From: Colin Dale <CDale@bfsengr.com>
Sent: Monday, March 2, 2026 7:04 AM
To: Derek Betz; Matt Hussung
Subject: RE: Des 2101166, R-43991, SR 127 - Proposed RW Reduction #2
Attachments: 7041U481-U481-6 - 2026-02-25.pdf

From: Derek Betz <DBetz@hanson-inc.com>
Sent: Tuesday, February 24, 2026 4:14 PM
To: Matt Hussung <MHussung@hanson-inc.com>; Colin Dale <CDale@bfsengr.com>; Wesley W. Downing <wes@az-engineering.net>; Daniel Paine <DPaine@hanson-inc.com>; Jeff Franciski <jfranciski@hanson-inc.com>; Indy Environmental <indy-environmental@hanson-inc.com>
Cc: Richard McPhail <RMcPhail@hanson-inc.com>; Jonah Thacker <JThacker@hanson-inc.com>; Jeff Stenger <JStenger@hanson-inc.com>; Jeff Bushur <JBushur@hanson-inc.com>; Lane Page <LPage@hanson-inc.com>; Nitin Timble <ntimble@az-engineering.net>; Marie Spitler <ESpitler@hanson-inc.com>
Subject: Des 2101166, R-43991, SR 127 - Proposed RW Reduction #2

We are once again executing a reduction in the RW on this project. This time it is on the Grandstand Plaza Property Owners Association property at the SE quadrant of SR 127 and Bickland Dr to avoid their sign.

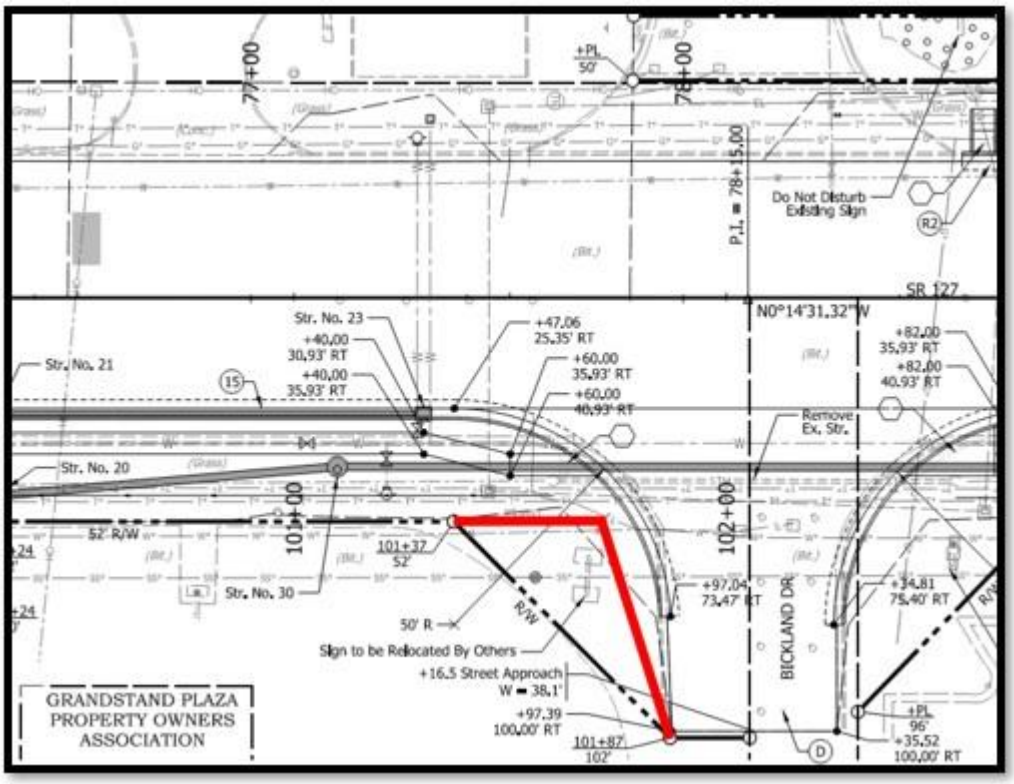
The vertex of the proposed RW line in question (see red line above) is moving from **101+37 Line "B", 52' RT** (approx. 77+47 Line "PR-A", 51.5' RT) to **101+70 Line "B", 52' RT** (approx. 77+80 Line "PR-A", 51.5' RT).

This will be a **reduction of 825 SFT** of permanent RW acquisition.

Colin and Wes—please update your plans to reflect the proposed RW change in this area (DXF and DGN attached) and send back updated plans next week when you can. ***It doesn't look like this change will require any changes to your designs, but please double check and confirm this.***
